寄件者: Tang Lok San <[REDACTED]>  
寄件日期: 2026年04月01日星期三 15:34  
收件者: tpbpd/PLAND  
副本: Athena Pui Yin LAI/PLAND  
主旨: S16 Planning Application No. A/YL-KTN/1224 Supplementary Document  
附件: AYL-KTN 1224 20260401.pdf  
類別: Internet Email

**A/YL-KTN/1224 申請詳細**

Proposed Temporary Open Storage of  
Construction Materials for a Period of 3 Years and  
Associated Filling of Land in “Agriculture” Zone,  
Lots 1290 RP (Part) and 1291 (Part) in D.D. 107,  
Fung Kat Heung, Kam Tin, Yuen Long, New  
Territories

**Submission for Compliance with Approval Condition (d) -  
the Implementation of the Accepted Drainage Proposal**

**Appendix I - Photographic Records of the Existing Drainage Facilities**

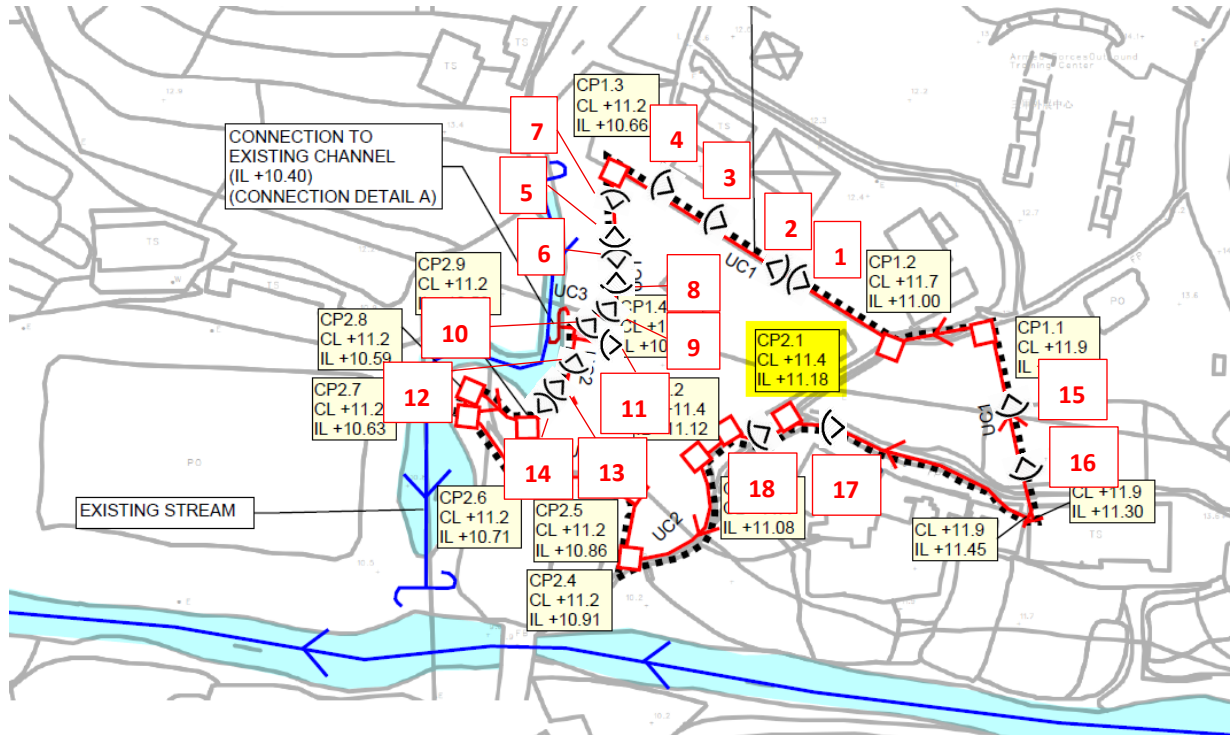
The as-built drainage system under the captioned planning application is not acceptable due to the following reasons.

1. The as-built drainage system was not constructed as per the accepted drainage proposal.
2. Some proposed drainage facilities shown in the accepted drainage proposal could not be seen in application site. The as-built drainage facilities should not be covered up by plants, machineries and other materials.
3. Debris was found in as-built drainage facilities that water flow would be obstructed.
4. Inadequate openings at the toe of the hoarding which may obstruct the overland flow.
5. An unknown 150 mm dia. pipe, which was not shown in the accepted drainage proposal, was improperly connected to the as-built catchpit CP1.1.
